NOTICE OF MEETING

- 1. APOLOGIES FOR ABSENCE
- 2. DECLARATIONS OF INTEREST
- 3. CONSIDER NOTICE OF REVIEW REQUEST: ANCHOR COTTAGE, CRINAN, LOCHGILPHEAD, PA31 8SW (REF: 20/0009/LRB)
 - (a) Notice of Review and Supporting Documentation (Pages 3 20)
 - (b) Comments from Interested Parties (Pages 21 46)
 - (c) Comments from Applicant (Pages 47 50)

Planning Application Ref: 19/02312/PP

LOCAL REVIEW BODY REFERENCE 20/0009/LRB

Extract from Bowman Stewart drawing 19-2639-P-01 Rev B showing Location Plan(not to scale)

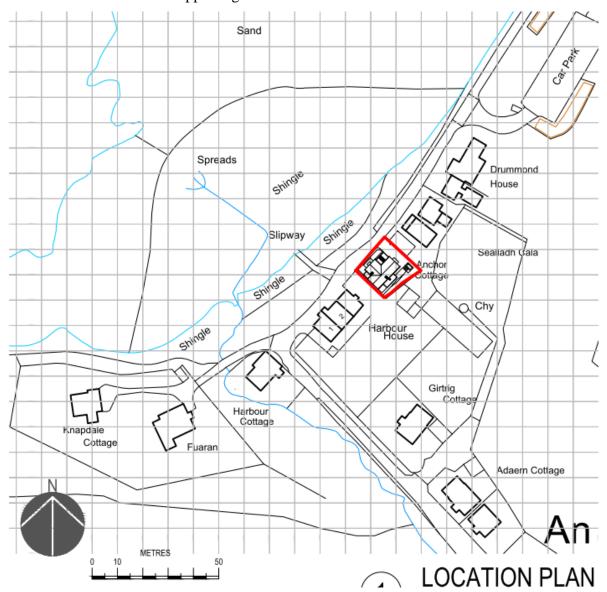
- 3. In argument against the second reason of refusal:
- Extension occupies a large proportion of the site and this does not tie in with the surrounding settlement pattern and character of the area.
 - a. I believe that this extension does in fact tie in with the surrounding pattern of buildings in this area, as the buildings to the North of this property are massed to the full width of their sites, from Anchor Cottage to Drummond House, as can be seen from the location plan extract below, the scale drawing is attached within the Supporting Documents:

Each house and boat shed are separately owned leaving small gaps or no gaps between each property. Therefore, our scheme is quite in-keeping with the local settlement pattern. I have also shown a photomontage showing the buildings in a line, showing the small gaps between each property.

- The group of buildings north of the appeal property do extend across the significant 3(a) majority of their respective plot widths as pointed out in the appellants' statement. However, in assessing the prevailing development pattern within the immediate area the planning authority has also taken into account, historic development to the South of the site. This is considered to be a reasonable and appropriate approach on the basis the development pattern of this attractive shore-side settlement should be considered as whole and not restricted to those buildings to the north of the site. It is noted that the appellants' photo montage is restricted to the appeal property and the buildings to the north. The rest of settlement directly adjacent to the south is excluded from the assessment and photo montage. This selective approach serves to 'skew' the appellants' analysis of the character of development in relation to development densities. For example there are significant gaps between buildings including between Harbour Cottage and no.1 Harbour House; between no. 2 Harbour House and Anchor Cottage (this open gap is within the curtilage of the former property with Anchor Cottage being within 500mm of its Southern side boundary); and between the Northern end of Anchor Cottage and the adjacent boat shed (proposed to be developed.) An appraisal of the wider setting of the appeal site therefore does not support the appellants' submission that the development pattern comprises almost continuous development across the full width of frontage plots with little or no gaps between. Rather, a wider and more appropriate analysis demonstrates that the development pattern comprises individual buildings and small groups of buildings with a variety of spaces between them, giving an informal and irregular rhythm between built form and open spaces between. It is considered that

these existing spaces, which set up this irregular rhythm and give intermittent views between otherwise continuous frontage development through to the wooded hillside setting behind, are instrumental to maintaining the established character of this settlement, especially in views from the public road and from the water. The extension of Anchor cottage across almost the entire width of the plot, and the resultant loss of an important space which contributes positively to its visual setting would be contrary to the development pattern of the settlement. Furthermore, the density of proposed development in relation to existing development pattern requires particularly careful assessment as the site lies within the North Knapdale National Scenic Area (NSA). This NSA is a statutory designation in the LDP as an area of landscape quality considered to be of national value. Within such nationally significant landscape, adopted LDP policy seeks to resist development considered to have an adverse environmental (including visual) impact.

Notwithstanding that the front wall of the proposed extension is set back behind the line of the existing cottage, it will still result in continuous two-storey development across effectively the full width of the plot. It will still result in the loss of an open space between built development which makes a positive contribution to setting of the cottage and this small hamlet, particularly when viewed from the public road and the water. The proposed development will be out of keeping with the local pattern of development as explained above.

Extract from Bowman Stewart drawing 19-2639-P-02 Rev B showing North Elevation. (not to scale)

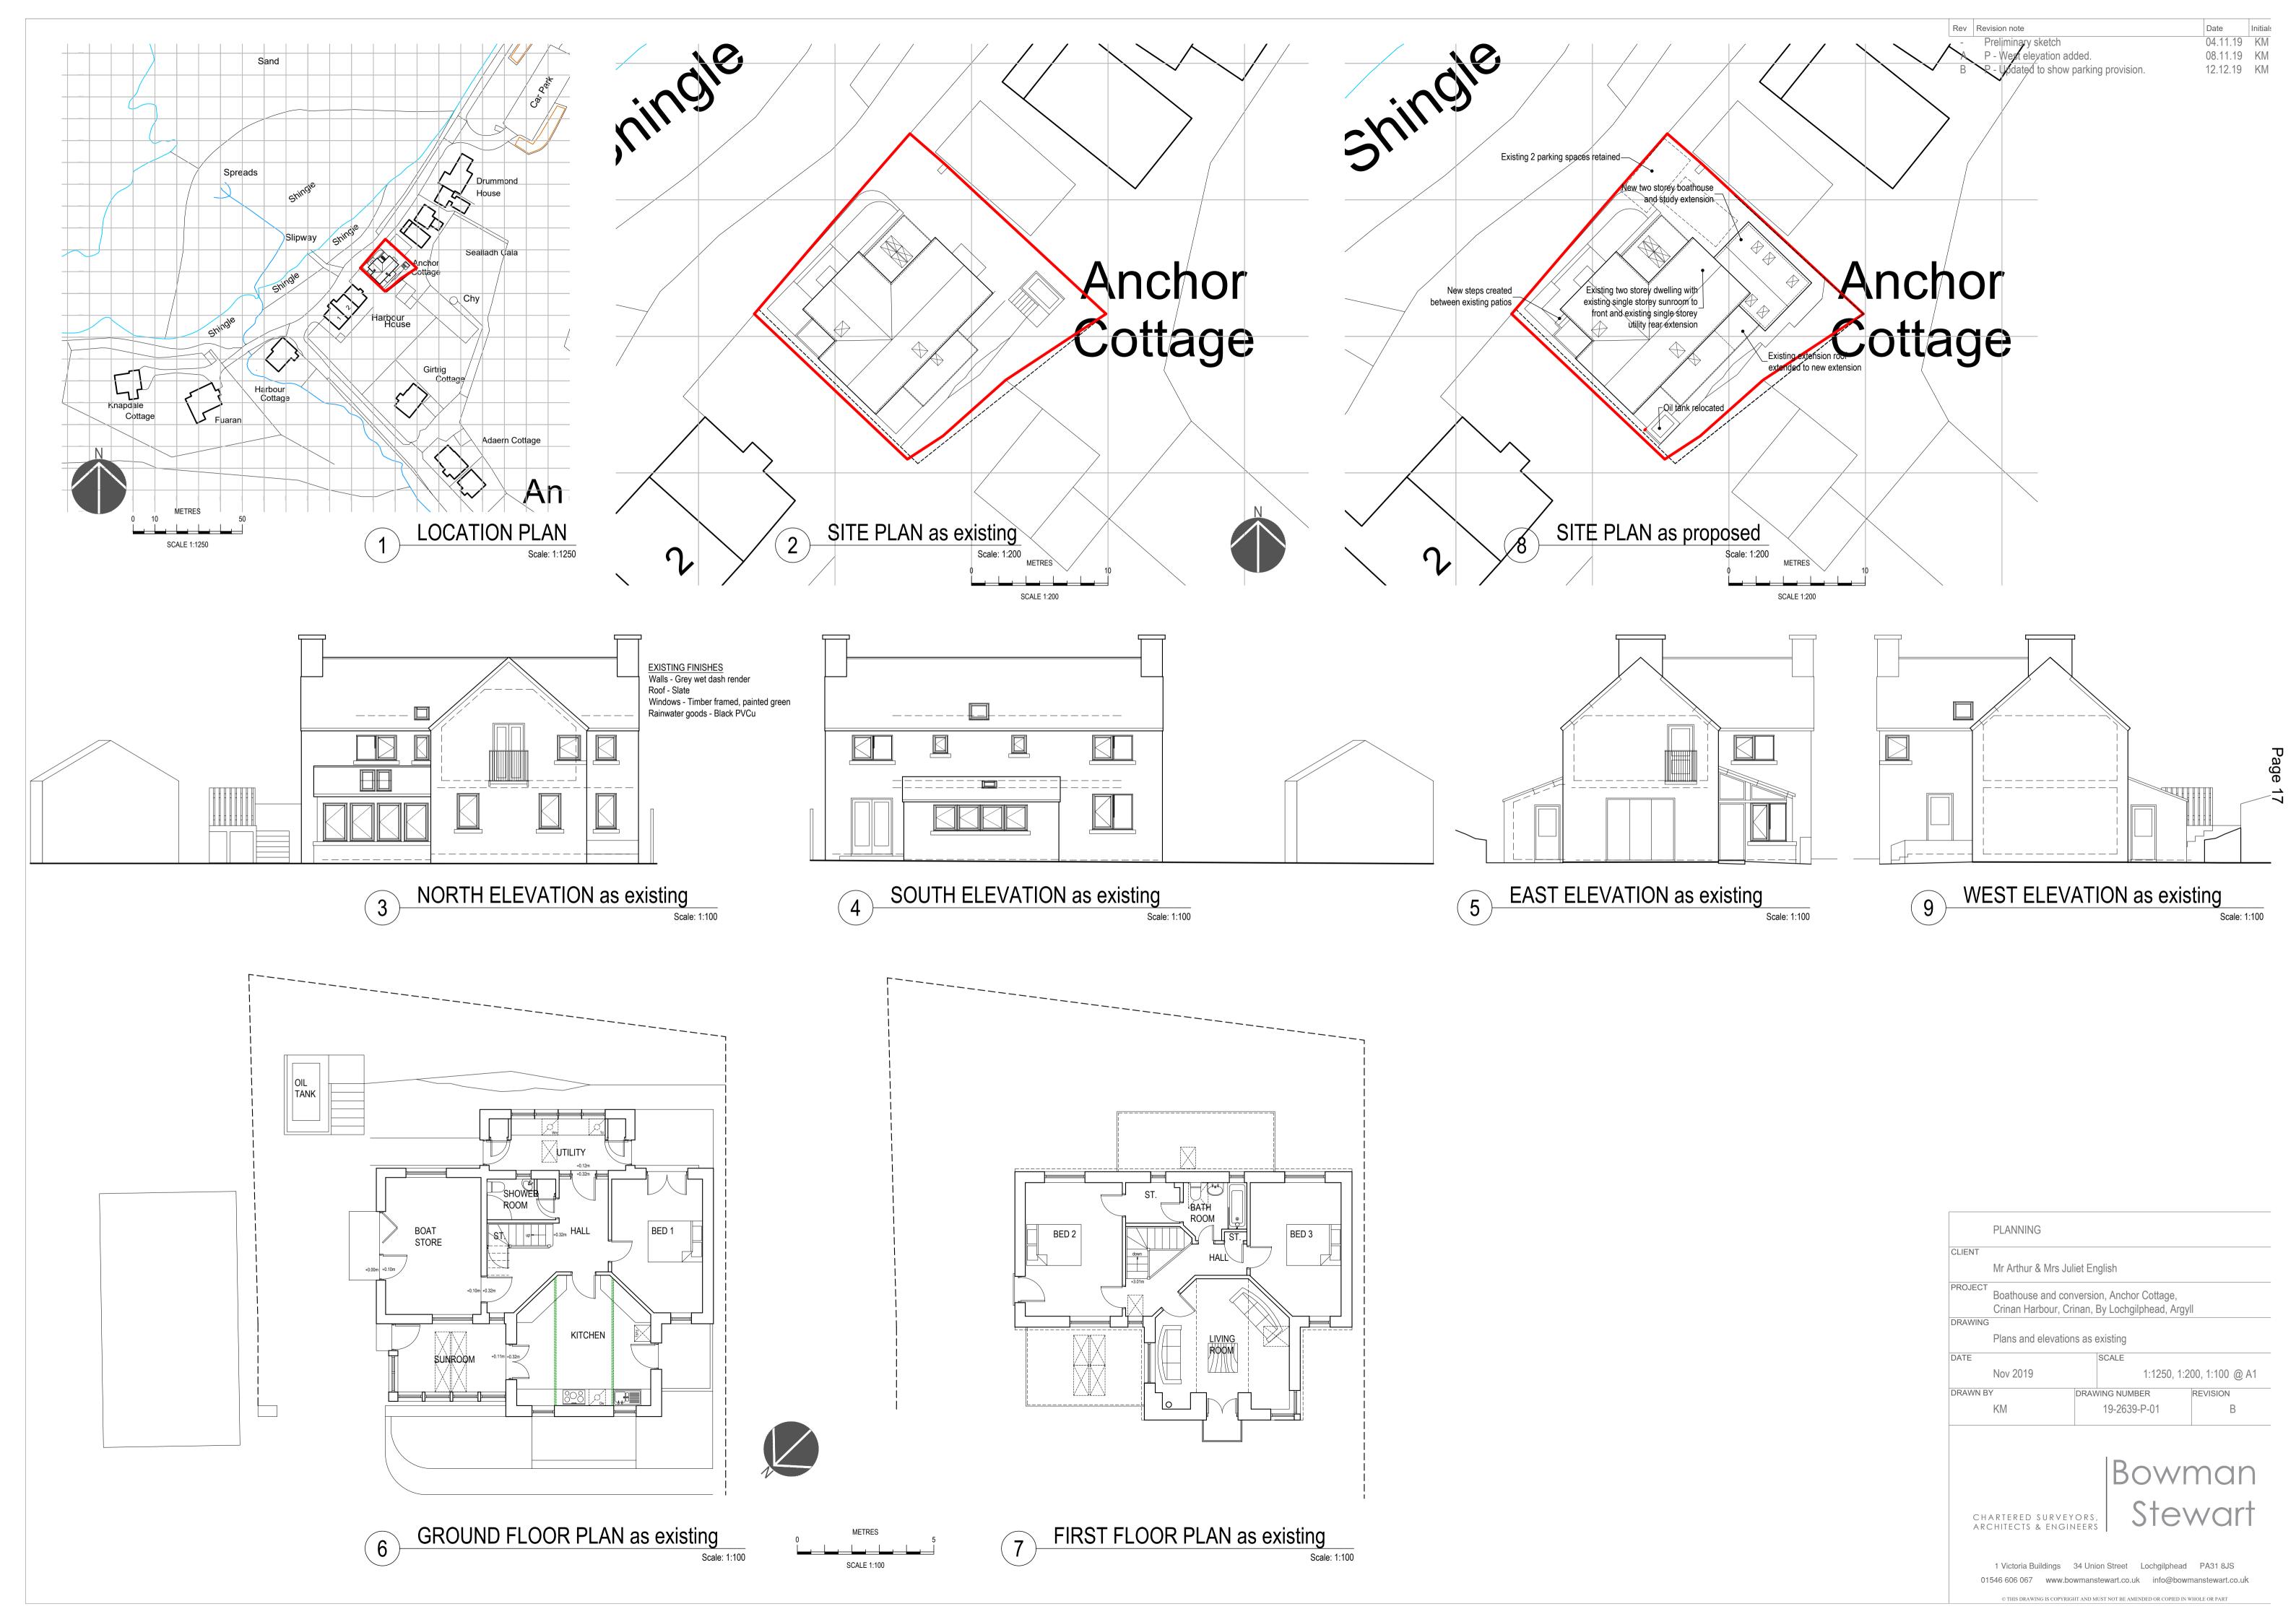
b. We were not given a chance to respond to this but it could be that due to the design of the extension having a pitched roof, and being set back, it may not interfere with the view from the public road and therefore this objection may not be relevant. I have shown an outtake of Google Streetview against the proposed elevation below for your information to see these side by side. Looking at these I believe one could very well still be able to see the scheduled monument from the Public Road.

In respect of the drawing excerpt showing the north elevation as proposed, positioned above a Google Street View image in the appeal statement, the Review Panel will be able to make an assessment of the extent to which the proposed extension will impact on the view of the Monument (in particular the chimney which figures prominently in the scheduling description.).

I would only point out that the level of the viewpoint from the vehicle-mounted camera used for street view recording is approximately 2.5 metres (or thereabouts) above ground level. Whilst the Google StreetView extract may provide a helpful indication, it should be taken into account that the actual visual impact is likely to be more severe than the extract as indicates as it adds some 700-900mm height to the viewers' perception. With reference to that extract image, the height of the extension to eaves level (i.e before the slope of the pitch of the roof starts to take visual effect) will be roughly level the rearwards top corner of the first floor opening to the Juliet balcony on the side elevation. The proposed extension from this viewpoint will extend to within 860mm of the side wall of the adjacent boatshed. The effect of this is that the proposed extension will extend across in front of the chimney element of the scheduled monument, obscuring it from view, or at the very least significantly compromising its integrity and setting. Taking into account the 'false' height of the camera viewpoint and the addition of the pitched roof form, in real terms, it is very doubtful if more than just the very tip of the top of the chimney will be visible after the proposed development. In the view of the Planning Authority, a possible glimpse of the tip of a chimney behind frontage development without an understanding of its contextual setting will be severely detrimental to the integrity and setting of this key visual element of a nationally significant monument. In the absence of an exceptional case, it is therefore maintained that the proposed development will have an unduly detrimental visual impact on the setting of a Scheduled Ancient Monument contrary to LDP policy.
